**NEWFOUNDLAND AND LABRADOR HYDRO  
BEFORE THE  
BOARD OF COMMISSIONERS OF PUBLIC UTILITIES**

**EVIDENCE OF EES CONSULTING ON COST OF SERVICE  
AND RATES**

**September 19, 2003 (Updated)**

Figure 1: Comparison of Billing Demands

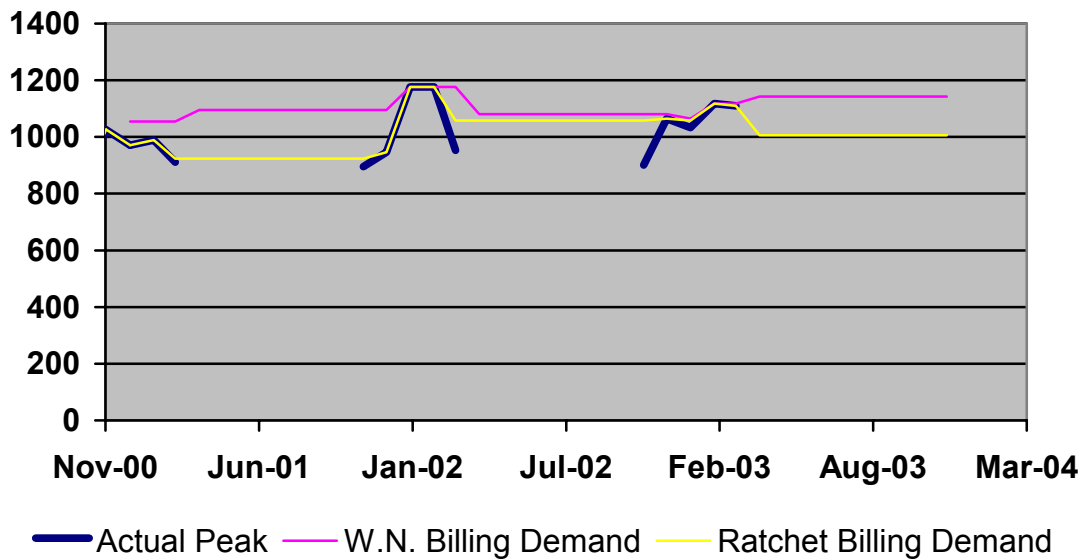
25  
26 Figure 1 below compares weather normalized and ratchet billing determinants against  
27 actual metered demand. In its response to PUB-181, Hydro did not provide actual  
28 metered peak demand in off peak seasons, so the figure below assumes that the ratchet  
29 always applies in off-peak months. In order to make an apples-to-apples comparison,  
30 EES Consulting has grossed-up Hydro’s proposed weather normalized billing demand by  
31 the 124.8 MW generation credit.
